**Descripción general:** El nuevo arnés en T FTI-STP1 requiere modificaciones para su uso en aplicaciones de transmisión automática (AT).

## FTI-STP1: Notas de instalación y configuración

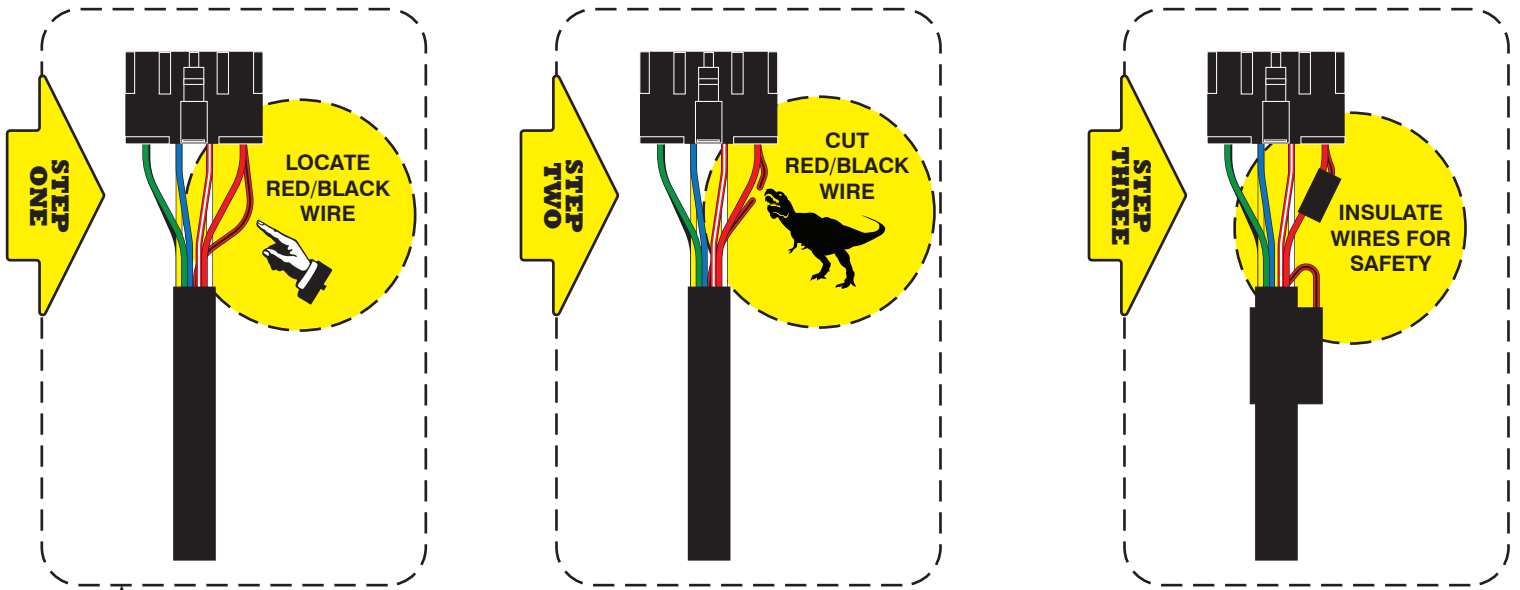
**Problema:** El arnés en T FTI-STP1 ha sido diseñado para ser compatible con AT (transmisión automática) y MT (transmisión manual), pero debido a una supervisión de la producción, el mecanismo de selección se estableció por defecto en el modo MT.

*El uso de un arnés configurado para una aplicación MT, en un vehículo equipado con AT, podría provocar daños en el módulo del vehículo. Se recomienda que el arnés vuelva al modo AT antes de instalarlo en vehículos equipados con transmisión automática.*

**Corrección:** Localice el cable rojo/negro (+ embrague) provisto en el conector CN1 del conjunto del arnés principal. Corte el cable rojo / negro, ya sea al ras del conector CN1 o dejando suficiente cable expuesto para que pueda aislar y asegure los extremos del alambre que quedan después del corte. Aísle cada uno de los extremos restantes del cable rojo/negro y asegúrelos para evitar cualquier posibilidad de cortocircuito.

**MODIFICACIÓN REQUERIDA PARA APLICACIONES DE TRANSMISIÓN AUTOMÁTICA ÚNICAMENTE**

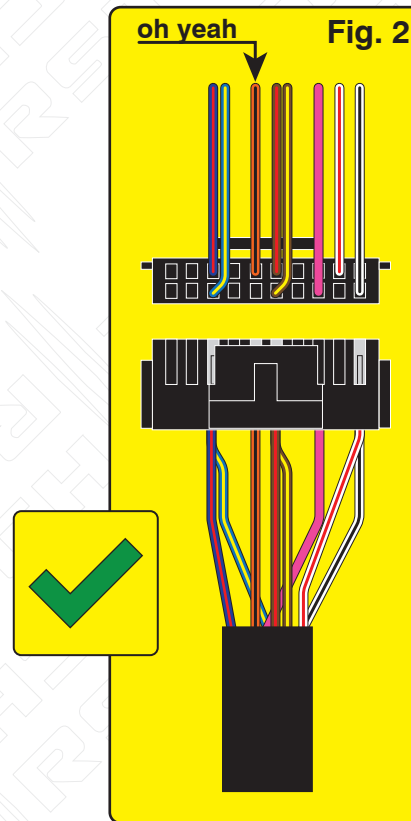
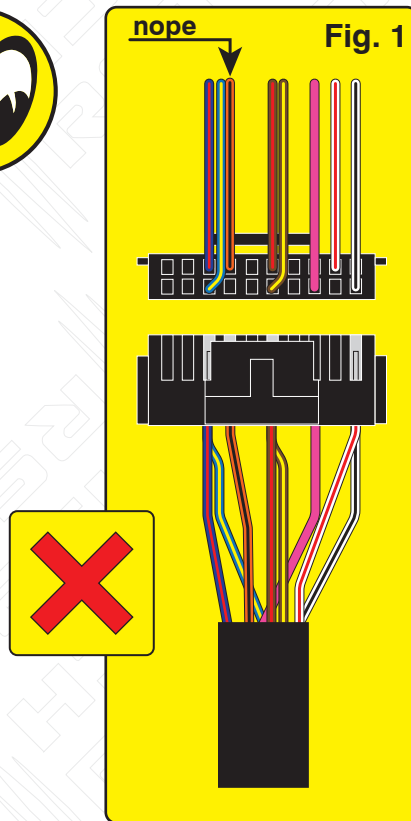
**Overview:** Production error; immobilizer wire (orange/black) in pin position #4 instead of pin position #5. Although an effort to correct the issue was made, some quantity of harnesses did get shipped before the issue was spotted. We are advising to inspect the harness BLADE connector before attempting to install the harness and program the module.

**Issue:** Module fails to program to vehicle, will not allow the vehicle to be remote started.

**Correction:** Step 1.) Locate the orange/black wire and confirm whether it is positioned as illustrated in Fig. 1 or Fig. 2. If the wire is as illustrated in Fig.1, proceed with Step 2 through 5 and complete the repair procedure outlined, if the wire is as illustrated in Fig. 2, correction is not necessary, proceed with harness installation and module programming.

**Step 2.)** Using a pick, lightly depress the catch that secures the terminal in the housing then remove the wire and terminal from the housing.

**Step 3.)** Using a fine tip razor or utility knife, insert the blade beneath the terminal catch and raise it slightly, so that it can be reused to secure the terminal when reinserted into the BLADE connector housing.

**Step 4.)** Refer to Fig. 2 for correct position of the orange/black wire (next to brown/red) then reinsert the terminal, pressing lightly until the catch 'snaps' into place, securing the terminal in the connector housing.

**Step 5.)** The repair is complete, proceed with installation and programming.
